Access Compliance Report

Public Rights-of-Way

Intersection ID: 53014	Main Street: ACADEMY_ST	Cross Street: CHARTRES_LN	Location: SE
ADA ID: DB25131DC4A9	Ramp Type: Perp	Initial Pass/Fail: Fail	Overall Compliance: No
Severity Score: 13.75			
Codes/Mitigation Info/Possible Solution		Field Measurements/Component Compliance

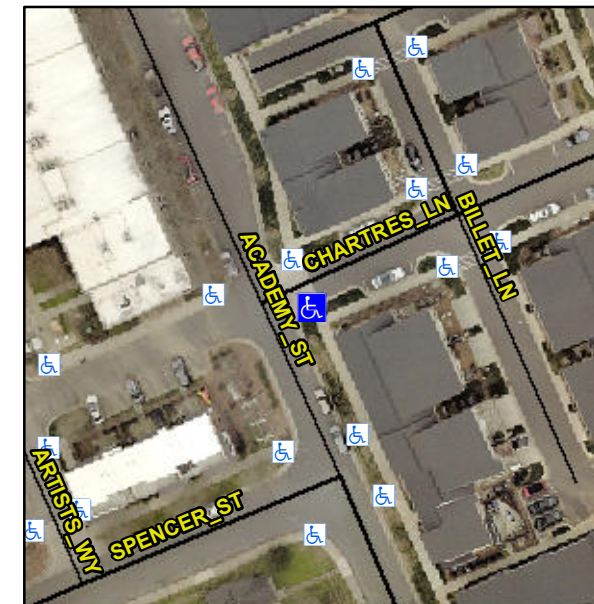
R304.2.2, R304.5.3

Compliance	Description	Data	Compliance	Description	Data
N/A	Ramp Length (in)	61.1	No	Ramp Slope (%)	10.7
Yes	Ramp Width (in)	72.0	No	Ramp XSlope (%)	2.4
N/A	Flare Type LT	N/A	N/A	Flare Type RT	N/A
N/A	Flare Slope LT (%)	N/A	N/A	Flare Slope RT (%)	N/A
N/A	Flare Traversable LT?	N/A	N/A	Flare Traversable RT?	N/A
N/A	Landing Length (in)	N/A	N/A	DWS Provided?	N/A
N/A	Landing Width (in)	N/A	N/A	DWS Contrast?	N/A
N/A	Landing Slope (%)	N/A	N/A	DWS Length (in)	N/A
N/A	Landing X Slope (%)	N/A	N/A	DWS Full Width?	N/A
N/A	Landing Curb? (Y/N)	N/A	N/A	DWS Offset (in)	N/A
N/A	Shared Landing?	N/A			
N/A	Gutter Ponding?	N/A	N/A	Gutter Slope (%)	N/A
N/A	Gutter Lip Ht (in)	N/A	N/A	Gutter X Slope (%)	N/A
N/A	Painted X Walk1?	No	N/A	Painted X Walk2?	N/A
	X Walk 1 Direction	To N		X Walk 2 Direction	N/A
N/A	X Walk 1 Width (in)	N/A	N/A	X Walk 2 Width (in)	N/A
	X Walk 1 Slope (%)	1.8		X Walk 2 Slope (%)	N/A
	X Walk 1 X Slope (%)	0.0		X Walk 2 X Slope (%)	N/A

Remove & Replace Entire Ramp.
